NON COMPLIANT ROOF
STRUCTURE SETBACK ELIMINATED

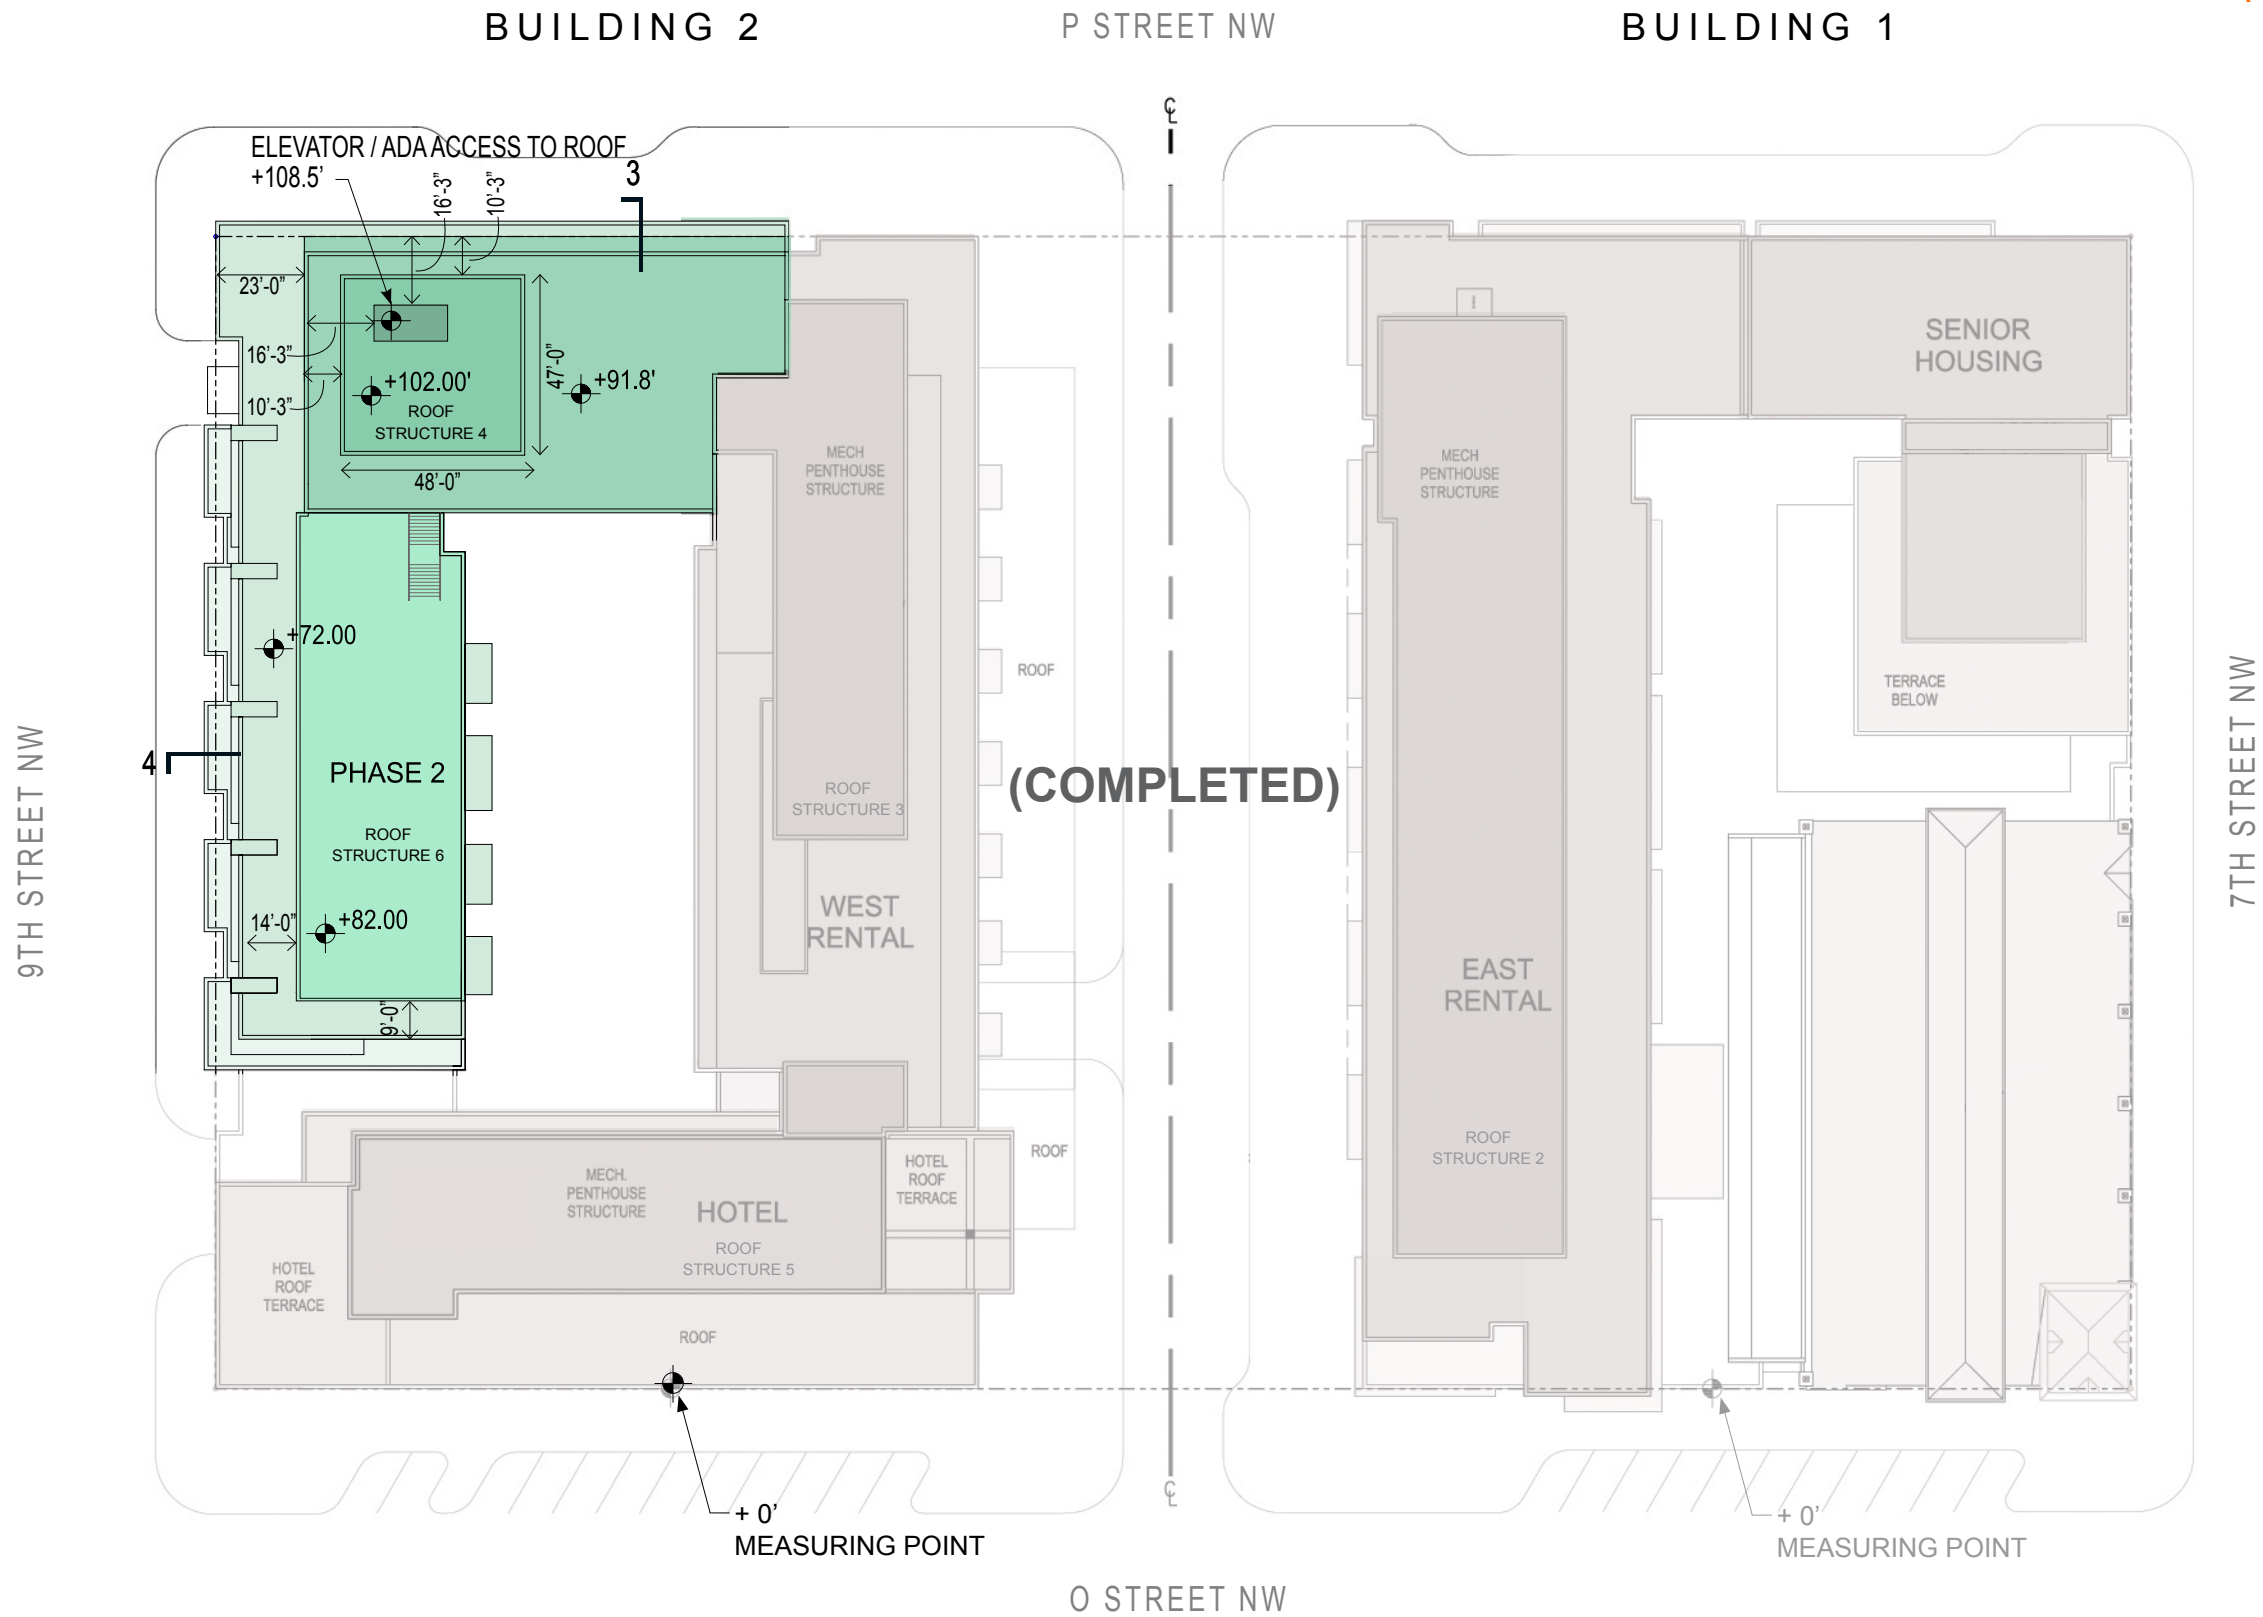
IN RESPONSE TO THE ZONING COMMISSION'S COMMENTS AT THE SETDOWN HEARING OF JUNE 26TH 2014, THE DESIGN OF THE PROPOSED ROOF STRUCTURE 4 AND ELEVATOR CORE LOCATION HAS BEEN MODIFIED TO ALLOW FOR THE 1:1 SETBACK REQUIREMENT TO BE MET. ROOF STRUCTURE 4 AND THE PROPOSED ELEVATOR POP UP HAS BEEN MODIFIED SO THAT THE ENTIRE ROOF STRUCTURE IS NOW COMPLIANT WITH THE 1:1 ZONING SETBACK MAKING THE ROOF STRUCTURE LESS NOTICEABLE FROM PUBLIC VIEW THAN IN THE ORIGINALLY APPROVED PUD. ENABLING THE ELEVATORS, LOCATED AT THE NORTH WEST CORNER OF THE BUILDING TO RUN UP TO THE ROOF WILL ALLOW FOR RESIDENT ACCESS AND THE NECESSARY ADA ACCESSIBILITY TO THE PLANNED ROOFTOP AMENITIES.
